Contents

Questions and Answers

[Question about template – RE: 07-2020 – 08/03/2020](#)

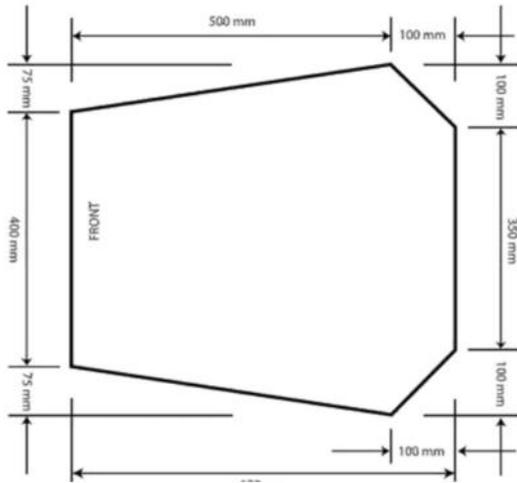
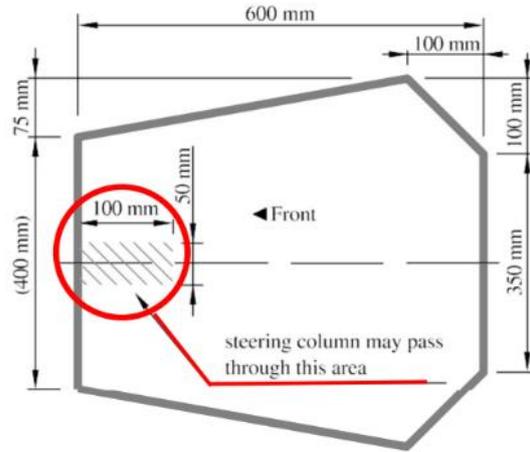
Question: FSAE rules T1.1.1 - cockpit opening template. We are designing our machine for it.

On attached picture left one shows Formula SAE Rules 2020. Right one shows local rule of Formula Student Germany 2020. A cockpit template of FSG has steering column pass through area.

In Australasia competition. Is it same or not?

Aerodynamic Mounting Off Main Roll Hoop Bracing RE: 11-2019 - 07/04/2019

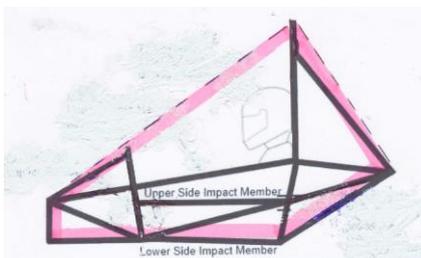
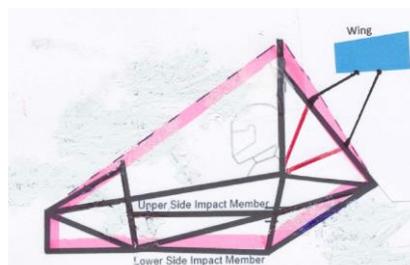
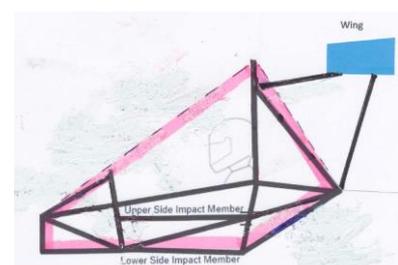
Question (part1): *I was planning to mount a bracket on the backside of the main roll hoop bracing that will then attach to the upper side of the rear wing as a mount (swan neck mount). However, I am confused as to what "additional bracing" must be added to the roll hoops to prevent bending loads in the braces in any rollover attitude?*

The three attached rough sketches should assist understanding the application of the rule, whereby the first shows a typical PS Envelope; the second shows a wing outside the PSE, mounted to the MRH Brace in a way that would require triangulation with additional tubes; the third shows an approach to mounting which does not load the Brace in bending and would avoid the need for additional tubes.
